产品开发更改

DC No. / 开发更改编号: PDECR_0016

Customer project Name/ 客户项目名称:	57cc e-compressor	MCR No. / MCR号:	BM-00095101_003
Affect Product No. / 产品号:	Component No. / 零部件号:		
所有57cc e-compressor成品		F01Z7A008T-01& 见如下:	
Sample type / 样品类型:	☐ A ☐ B ☒ C ☒ FD	Initiator/发起人:	Fan Change (RBCD/EIS4)

8: offer drawing 增加追溯码备注和描述:

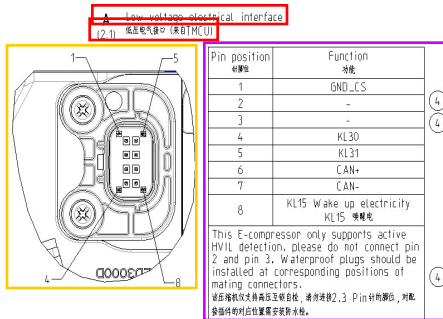
All DMC and traceability codes 所有二维码和追溯码

Except for the nameplate, all DMC and traceability codes are internally used by Bosch, the illustration is only for reference, pls refer to the actual product for accuracy and should not be subject to dimension or visual inspection criteria. 除铭牌外, 所有二维码和追溯码均为博世内部使用, 图示仅供示意, 请以产品为准, 不作为检查项目.

Offer drawing 电气接头信息变更
